# **PREDETERMINATION SETTLEMENT AGREEMENT**

CP# 08-16-69457  
HUD# 07-16-4729-8

Complainant specifically alleged, in Unit 101, 4128 Lincoln Swing Street, Heights at Lincoln Swing [“Lincoln Swing”], two features within one of the covered ground-floor units appeared inaccessible to a person utilizing a wheelchair for mobility – (1) except for the kitchen and the bathroom, the midline of the lower electrical outlet at the receptacles throughout the unit were located 10 ½ inches above the finished floor, which is less than the 15-inch minimum allowed height for electrical outlets; and (2) the clearance from the midline of the sink to the wall was measured at 18 ½ inches in one bathroom and 18 ¾ inches in the other, both of which are less than the 24-inch clearance required for a parallel approach needed because the cabinets underneath the sinks, as observed by the tester, were not easily removable.

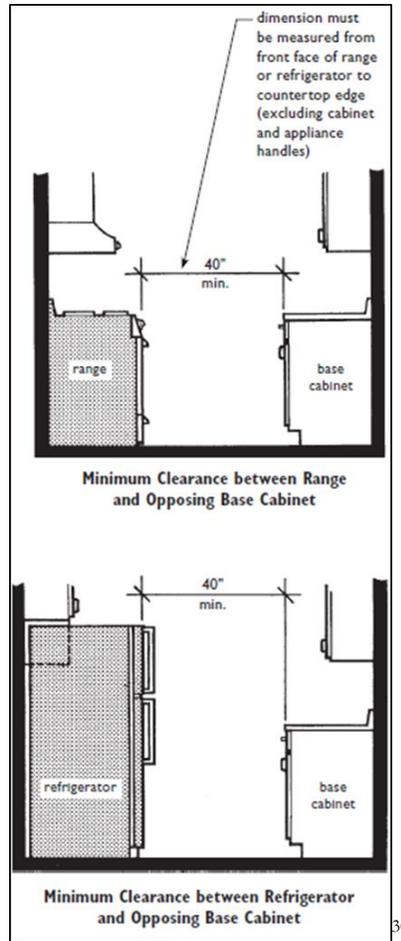
(a) The parties agree the height onto the finished floor surface of the interior threshold at the sliding glass doorway of all inspected ground-floor units exceeds the <sup>1</sup>/<sub>4</sub>-inch maximum height allowed for interior thresholds without beveling, as established by the Manual.

(b) Owners agree they will install a ramp – with a running slope of  $\leq 8.33\%$  – at the interior side of the threshold to the sliding glass doorways of all ground-floor units as required by the Manual.

(c) If rubber ramps are used, Owners agree to annually inspect and, if necessary, replace any ramps that have become unsafe or unusable due to deterioration.

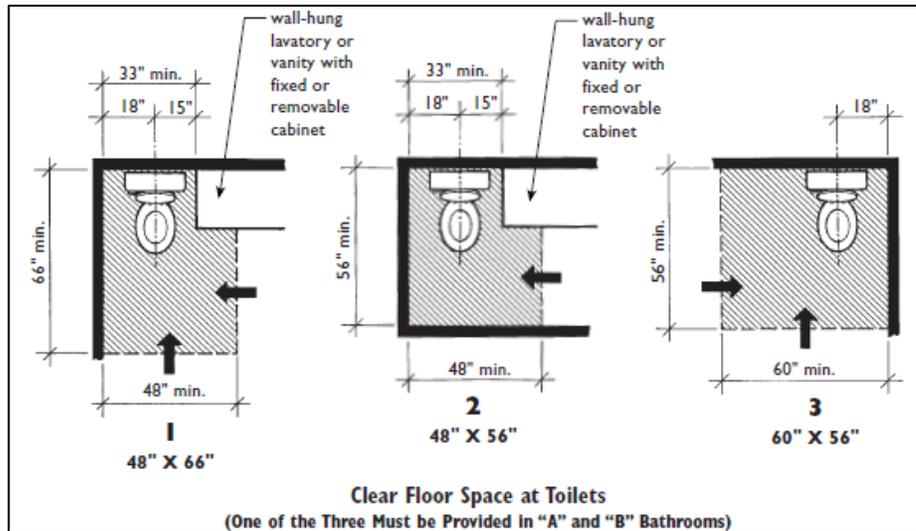
(a) The parties agree the distance from the midline of the sink to the adjacent wall in the bathrooms of the inspected units, as reported on page 5 of the current agreement, was measured at under the 24-inch minimum for bathroom sinks without removable cabinets, as required by the Manual.

(b) The parties agree the distance from the midline of the toilet to the bathtub (grab-bar side) in Unit 104 is 17 ½ inches, which is less than the 18 inch-minimum requirement; and is 14 ½ inches to the vanity cabinet (non-grab bar side), which is less than the 15-inch minimum requirement, as established in the Manual.

(c) Owners agree they will correct the deficiencies noted in paragraph “(a)” above by replacing the current vanity cabinets with removable cabinets such that:

i. The midline of the toilets meet the requirements of the Manual, as shown in the figure below:
